## ADDENDUM NO. 1

**DATE: September 23, 2015**

Contract 15-C-00040; West River Trail Phase 2 U.T. – Sheltered Market

SHEET: C3.0

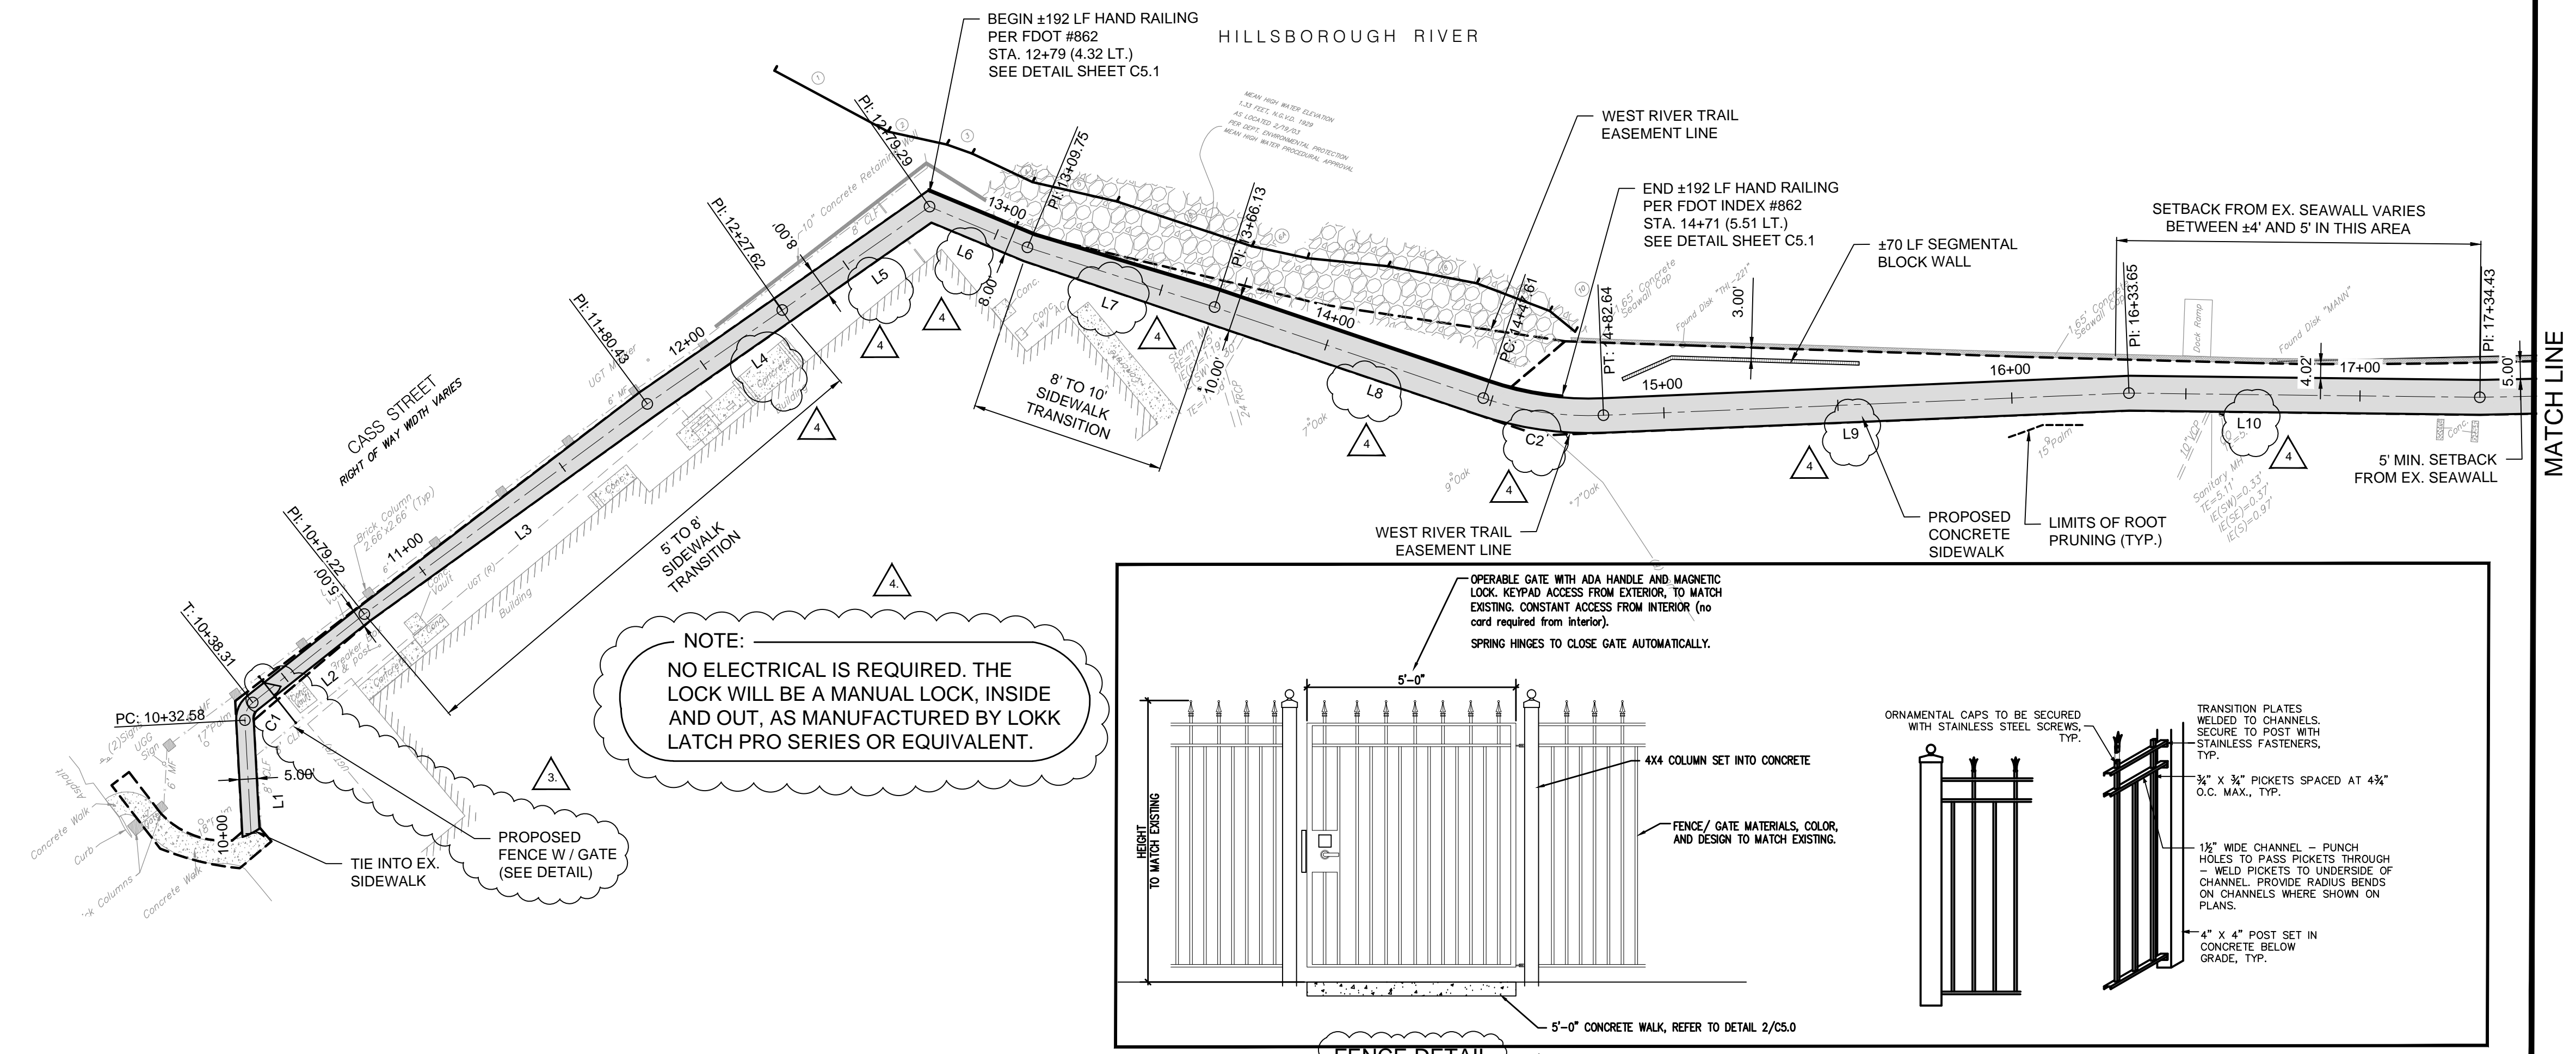
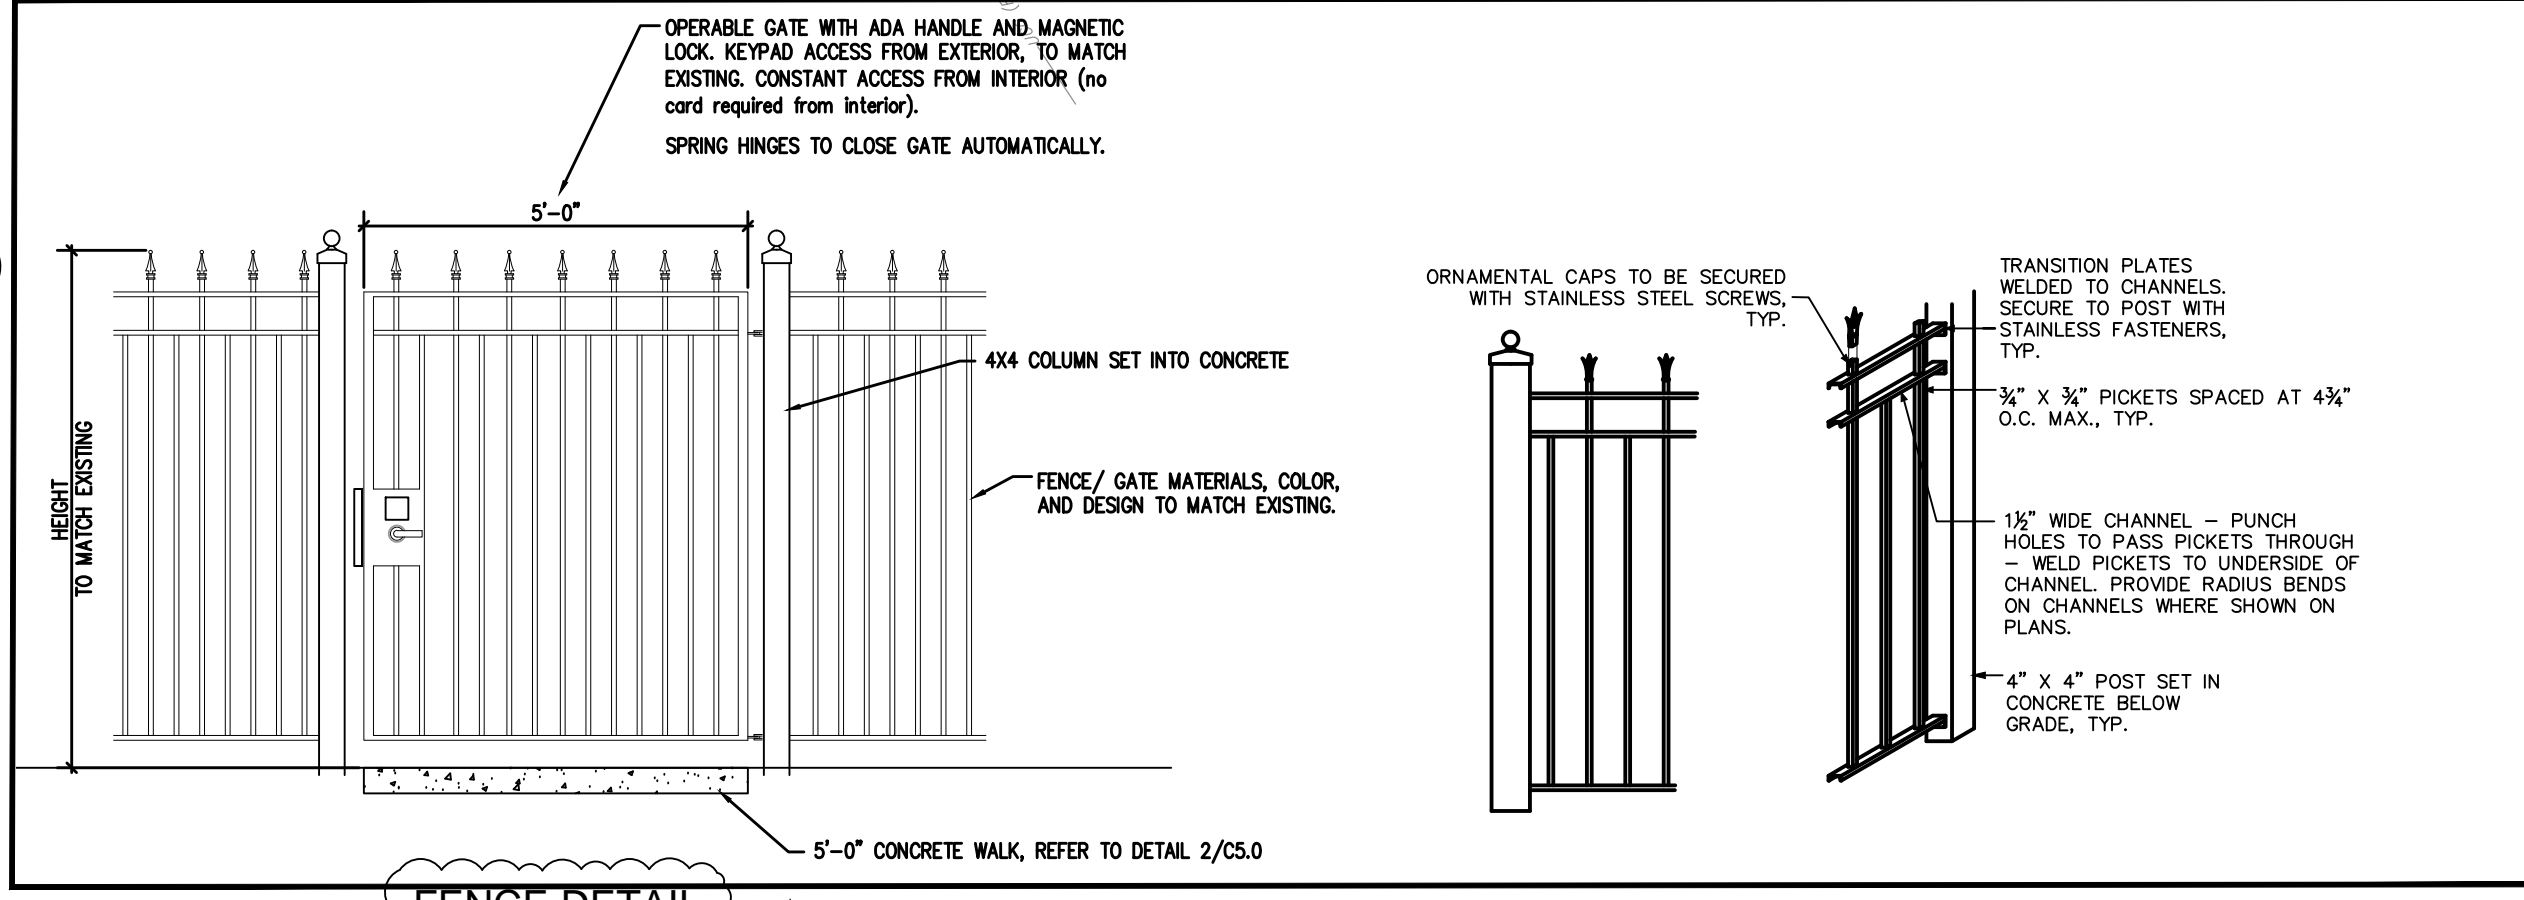
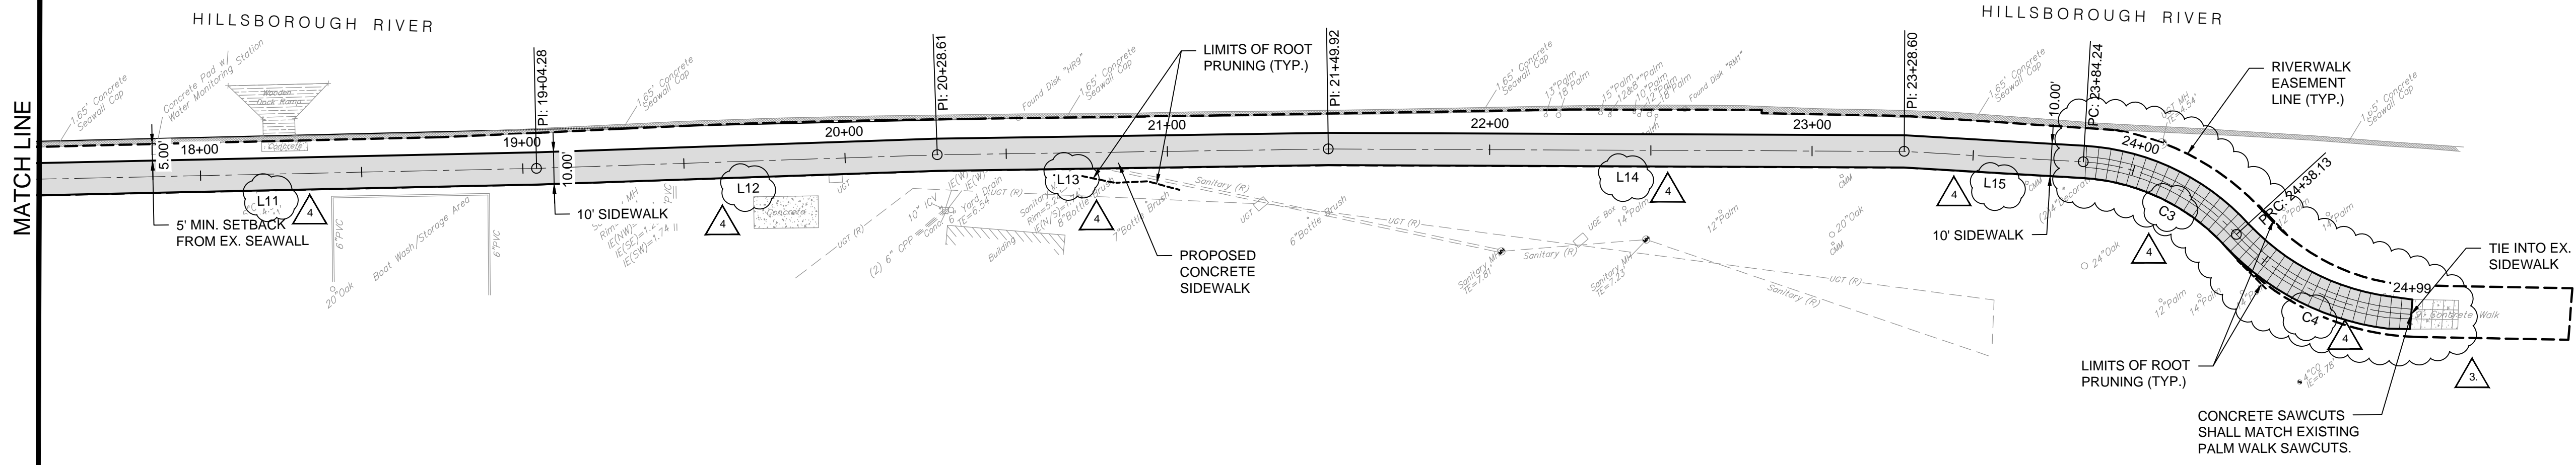
Item 3: Replace Drawing C-3.0, with attached Drawing C-3.0, revised 09/21/15. This Drawing Sheet revises the line table information and curve numbers revision. The line and curve numbers were revised and sequentially numbered to match the table.

Operable Gate, Clarification: No electrical is required. The lock will be a manual dual lock, inside and out, as manufactured by Lakk Lath Pro series or equivalent.

NOTE: NO ELECTRICAL IS REQUIRED. THE LOCK WILL BE A MANUAL LOCK, INSIDE AND OUT, AS MANUFACTURED BY LOKK LATCH PRO SERIES OR EQUIVALENT.

1 SIDEWALK JOINT DETAIL

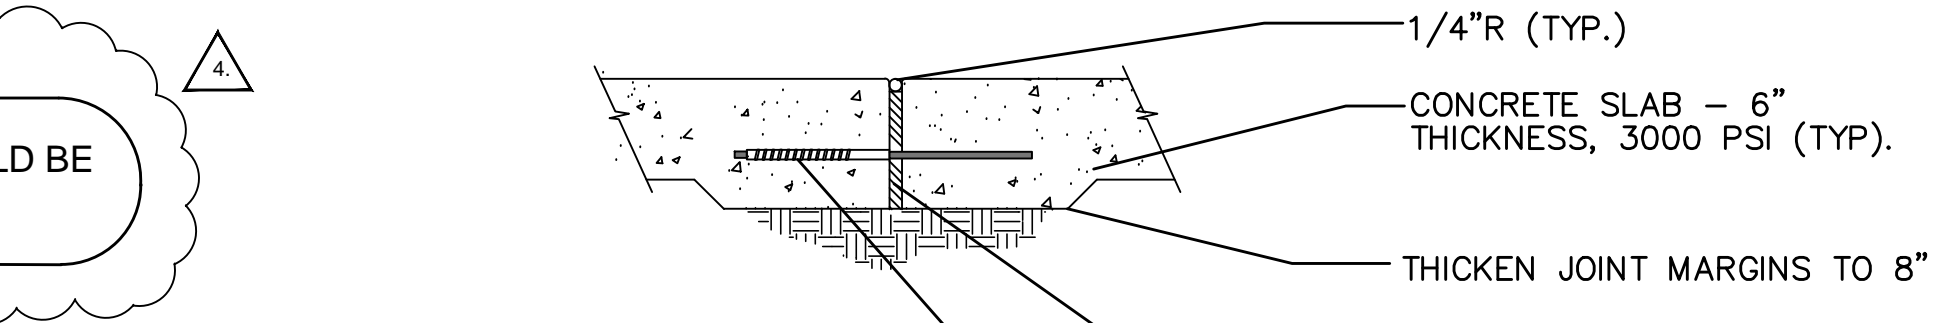
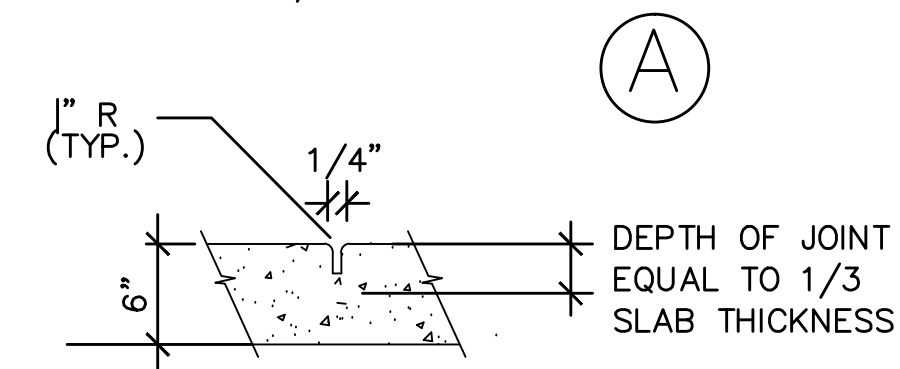
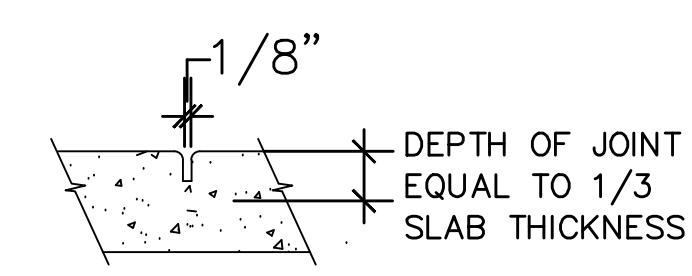
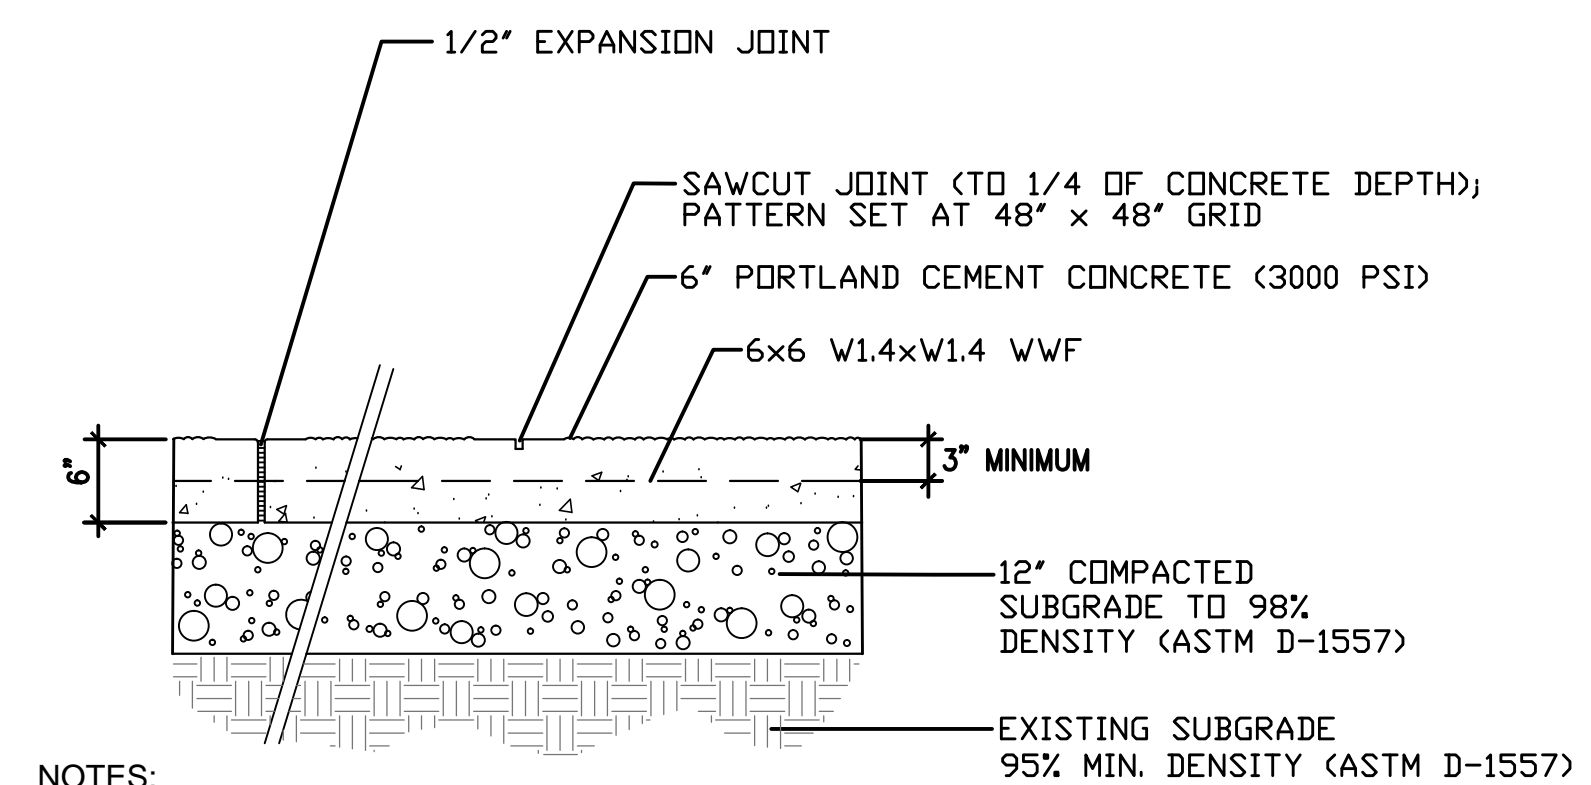
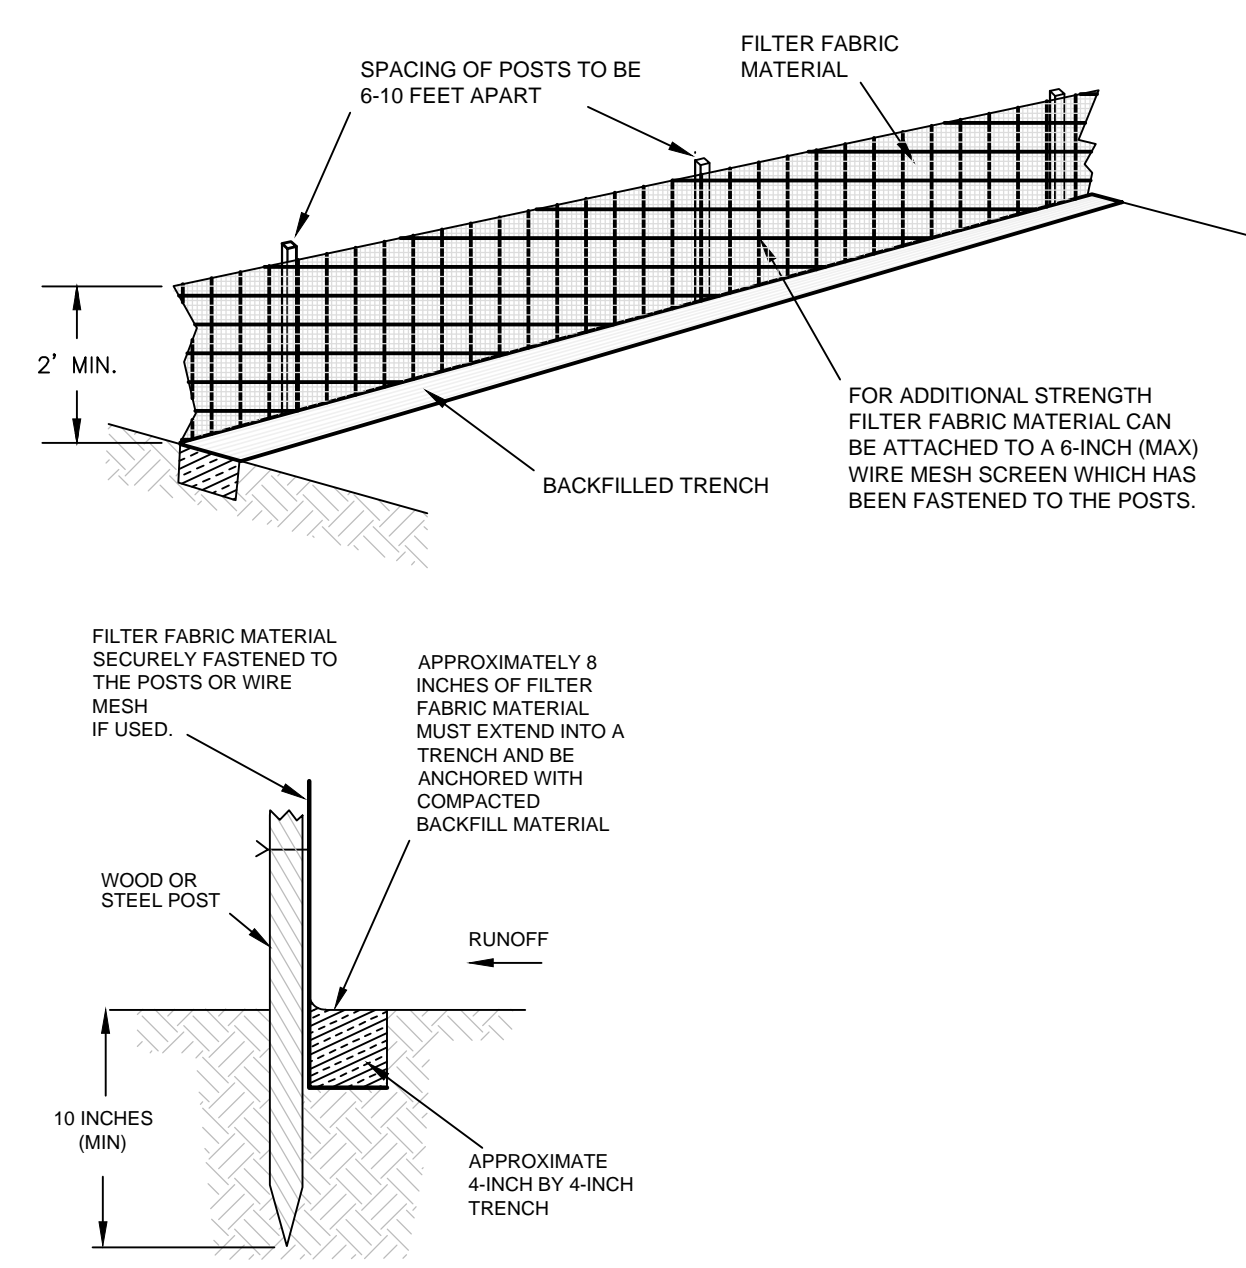
Item 4: Replace Drawing C5.0 with the attached Drawing C-5.0, revised 09/21/15. Dowel Spacing Clarification: Spacing of the dowels should be 18" O.C.

NOTE:  
SPACING OF THE DOWELS SHOULD BE 18" O.C.
